PERIPHERAL EQUIPMENT DIVISION

TITLE DOOR OPENER BAIL HEIGHT ON FRONT LOAD DISK DRIVES			PIB NO. DK-3019	
PRODUCT LINE TAPE DISK FORMATTER	EQUIPMENT CHANGED 102624-01	MODEL SERIES AFFECTED D3000	EFFECTIVE DATE 1-15-75

TITLE DOOR OPENER BAIL HEIGHT ON FRONT LOAD DISK DRIVES

FIB NO.
DK-3019

Figure 1

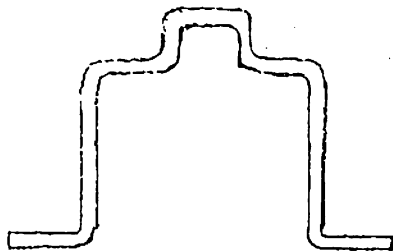
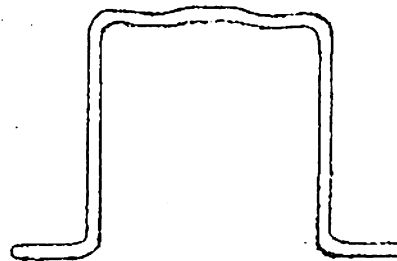
DESCRIPTION: The door opening mechanism (P/N 102624) has been re-designed to avoid a possible worst case condition involving 2315 type front load disk cartridges. ANSI (American National Standards Institute) specifications require that the access door be opened 1.650 inches, (41.91 mm) minimum. There is, however, no dimension for the height of the retainer to the sector hub once the access door is open. Therefore, the possibility could exist that a marginal pack could possibly make contact between the retainer and the sector hub. The redesigned door mechanism will open the access door wider by approximately .030 prohibiting any worse case conditions. Figures 1 and 2 will portray physical differences of old and new style respectively.

- Audible noise coming from disk pack during up sequence.
- Shaved off plastic inside cartridge.
- Unexplainable head to disk contact where shaved off plastic is present, either in cartridge or on positioner.

- 1.0 Remove AC power from disk drive.
- 2.0 Remove dust cover and extend PCBA's to the service position.
- 3.0 Remove cartridge receiver Assembly (P/N 102751)
 - 3.1 Remove four hex head cap screws that secure the pivot support screws at rear of receiver assembly.
 - 3.2 Remove Receiver Assembly.
- 4.0 Using snap ring pliers remove old door opening mechanism.

NOTE HOW TORSION SPRING IS WOUND
SO AS CORRECT TENSION MAY BE
APPLIED DURING REINSTALLATION.

- 5.0 Install new door opening mechanism and reverse removal procedures.
